## CITY OF ALBUQUERQUE

Re: Storage Facility for Derron

**Traffic Circulation Layout**

Engineer's/Architect's Stamp dated 3-10-16 (K15-D096)

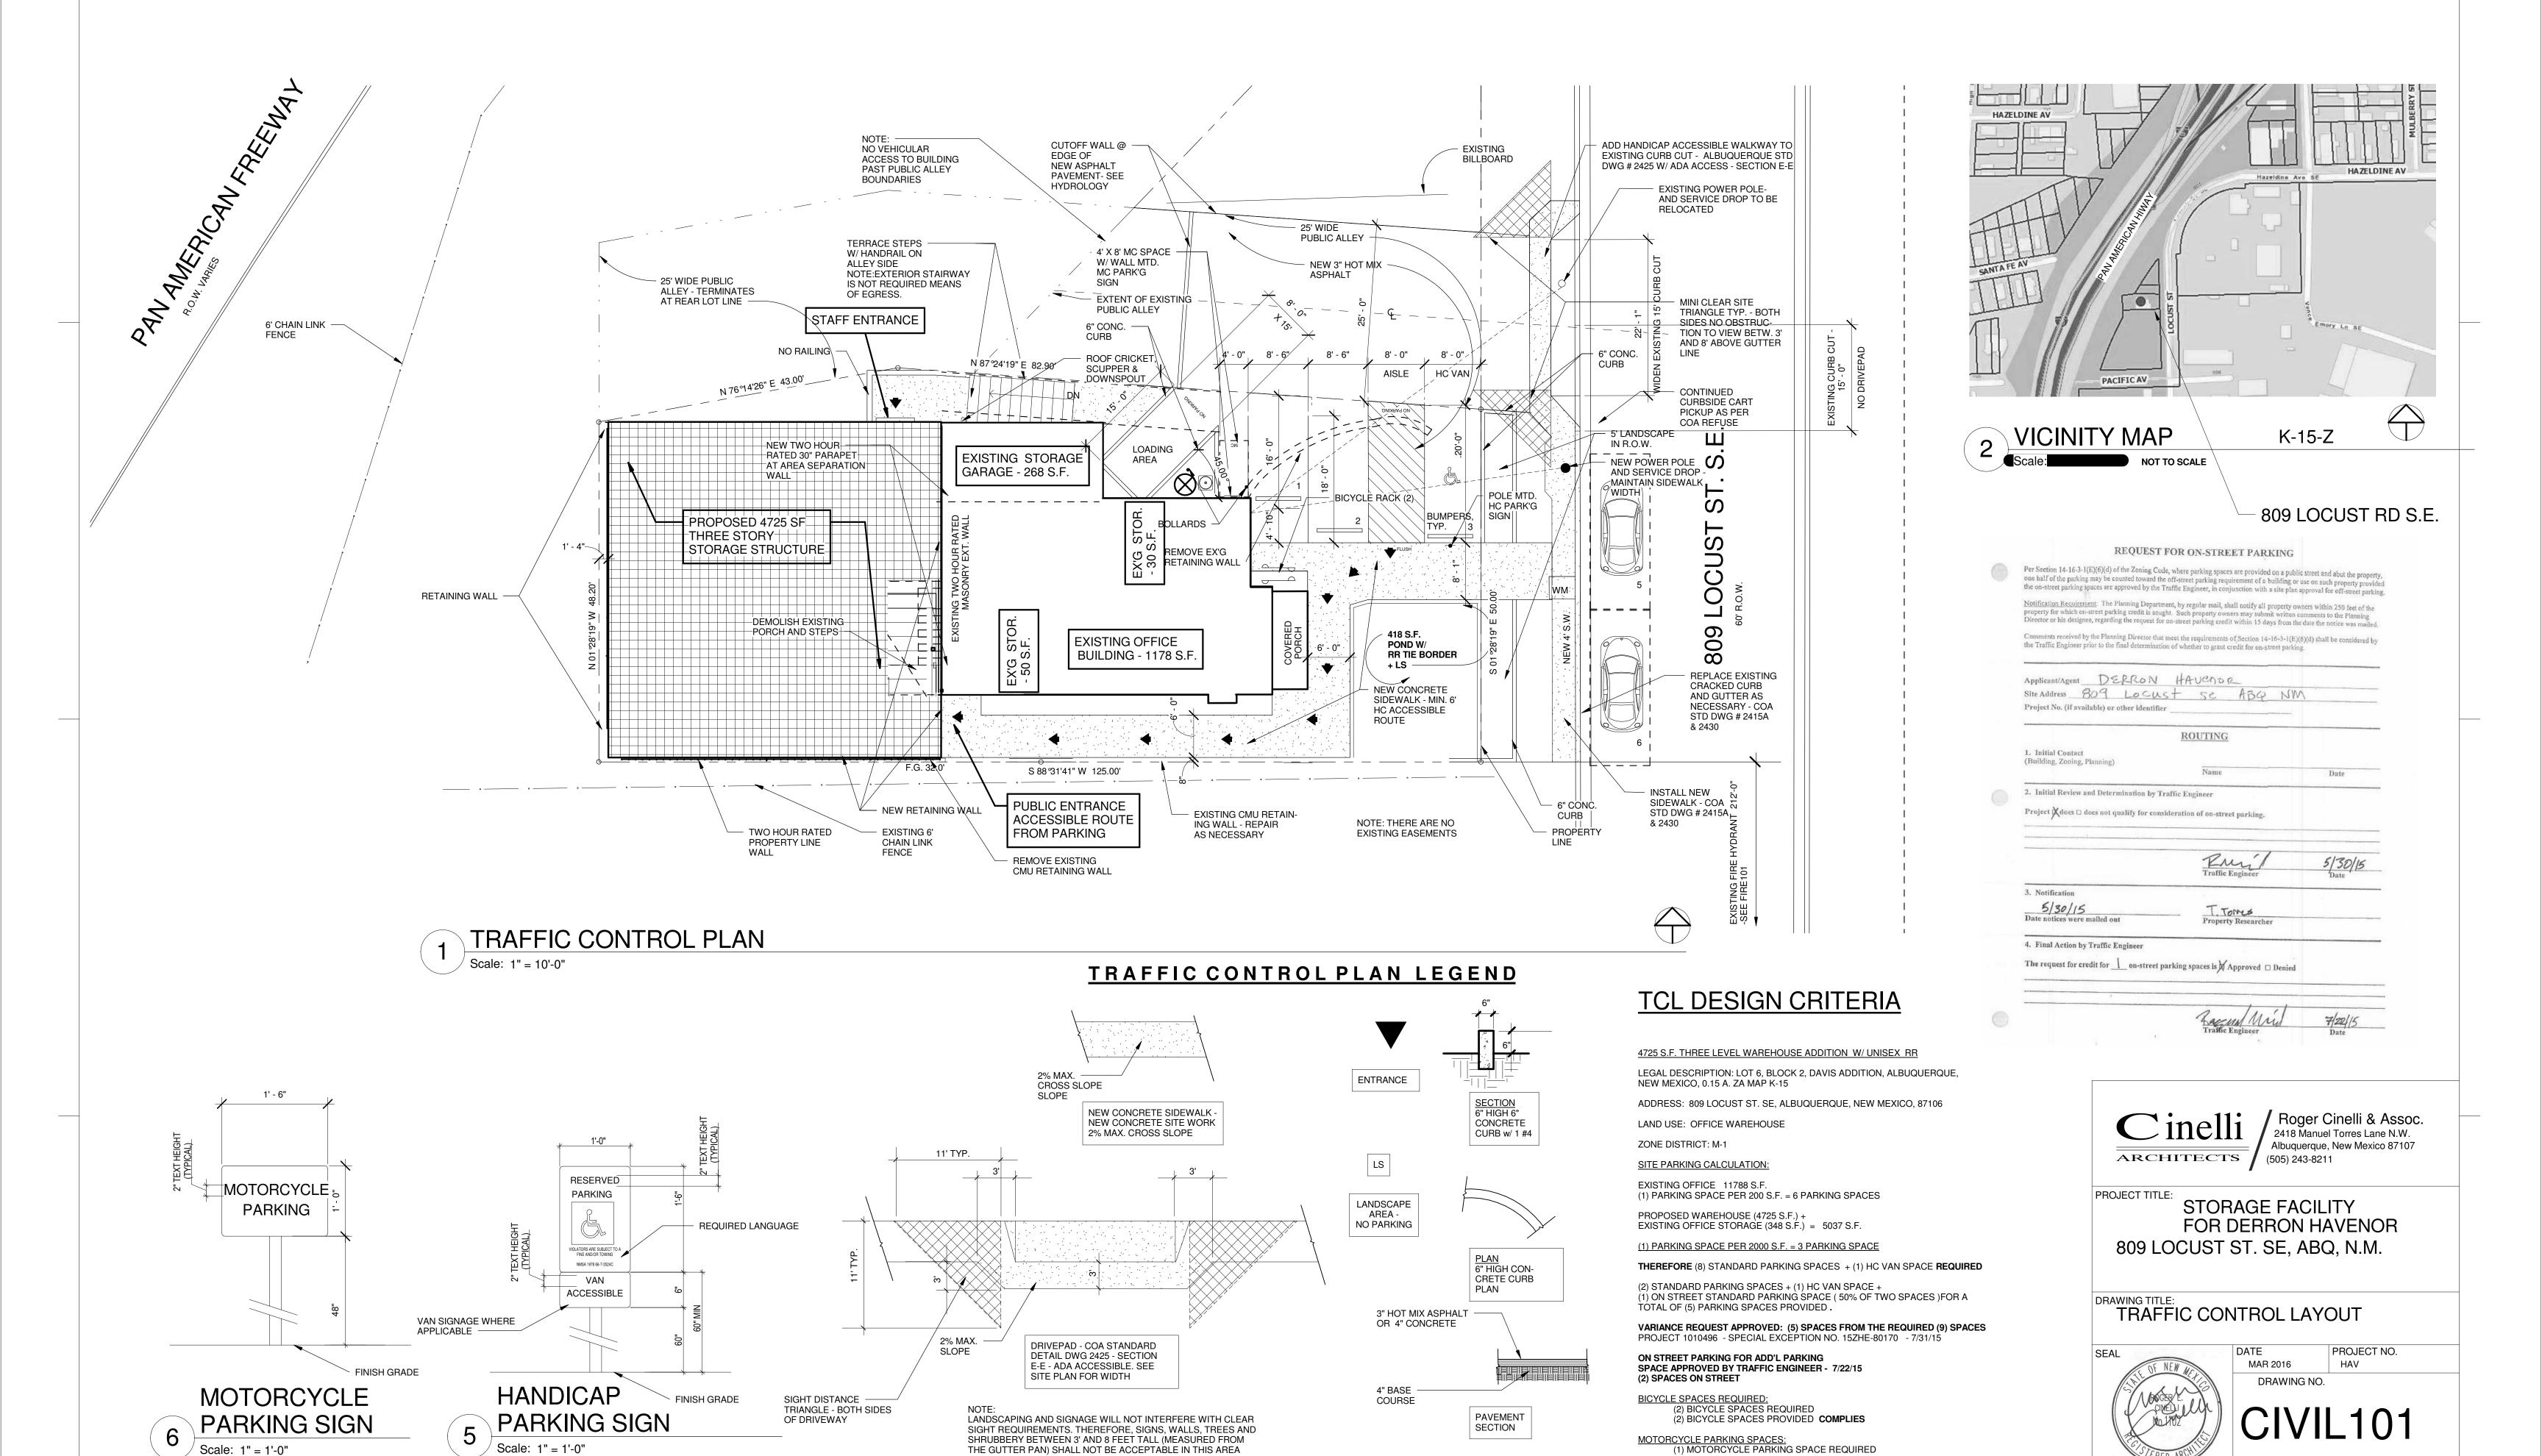
We have formally approached the Zoning Department regarding the reduction in the on site parking space requirement. Mr. Vince Montano and Mr. Andrew Garcia have approved the on site parking spaces from (4) spaces to (3) spaces. These include an 8'-6" wide x 16' space, a 8'-6" x 18' parking space and a 8' x 20' handicap van parking space with an 8' aisle space adjacent. The former diagonal compact car space will be used for minor off loading of items. It will be headered by a no parking sign on the asphalt.

As regards the drivepad width; solid waste is permitting continued cart refuse pickup. Given the presence of (2) on street parking spaces that take up limited project frontage on Locust, the only area that is available is South of the drivepast. For that reason, we respectfully request a widening of the existing 15'-0" drivepad to the 22'-0" width. Only (3) parking spaces are being served.

The TCL submittal received 3-22-16 is approved for Building Permit. A copy of the stamped and signed plan will be needed for each of the building permit plans. Please keep the original to be used for certification of the site for final C.O. for Transportation.
